SERVICE BULLETIN: SB03232001, Inspection and Repair of Lift Shaft and Adjustment of the Gas Shock Absorbers

Affects all VR2002E, MT3000E, VR2002E, and FS2000E, all electric simulators, manufactured by MaxFlight Corporation.

Lift Shaft Coupling Alignment check Down Stop Shock Adjustment

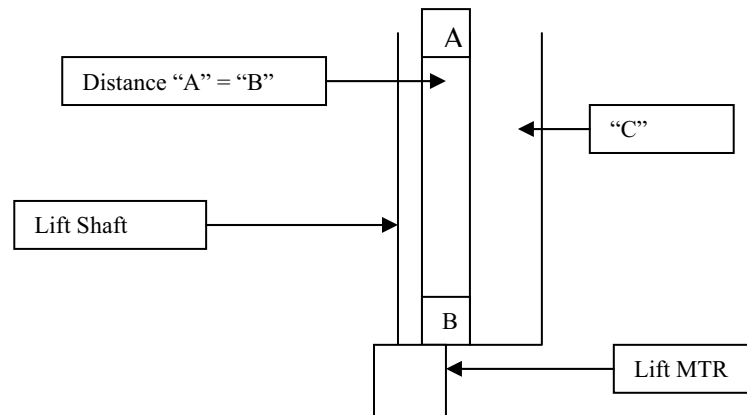
Purpose of the check is to verify straight alignment of couplings to respective drive to prevent vibration that would cause loosening of the couplings.

Visually check straight alignment between output of lift motor to gear box input horizontally.

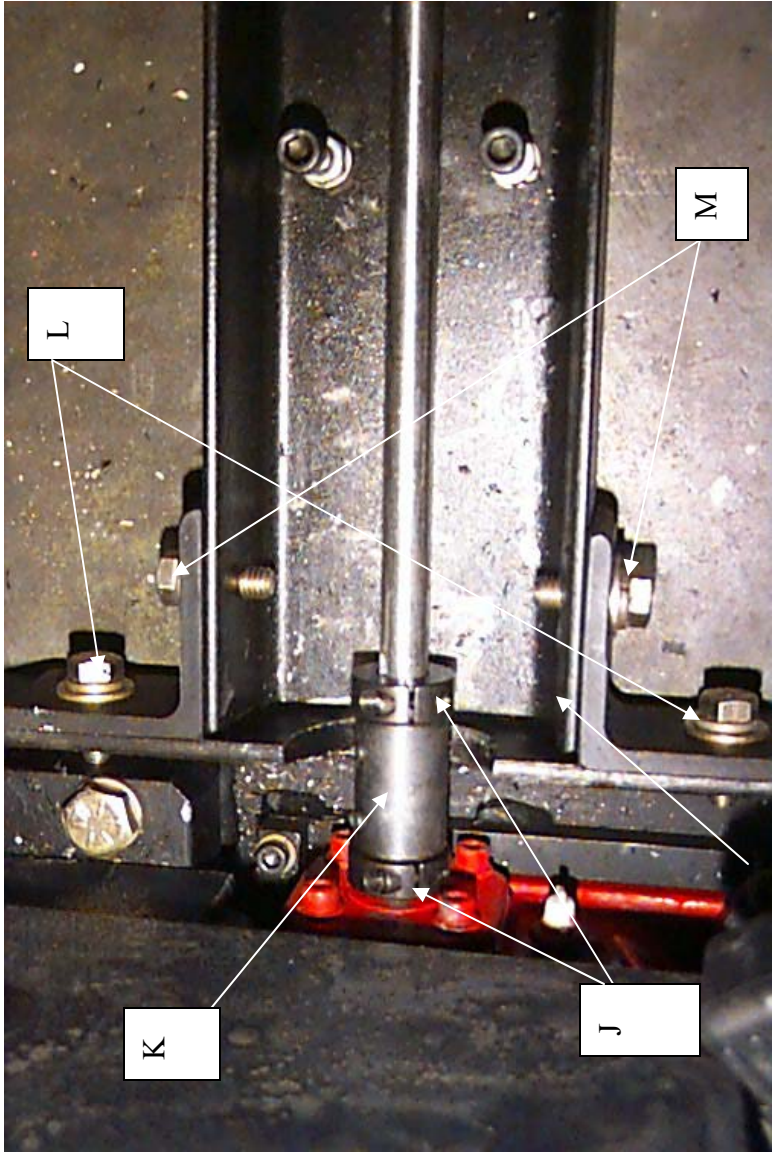
Measure distance from outside edge of lift drive shaft to edge of base "C" channel at the 90 degree gear box side.

Measure the distance from outside edge of lift drive shaft to edge of base "C" channel at the lift motor end.

Both distances must be equal to obtain lift shaft parallel alignment to base "C" channel. This will prevent abnormal wear and vibrations in the lift system.
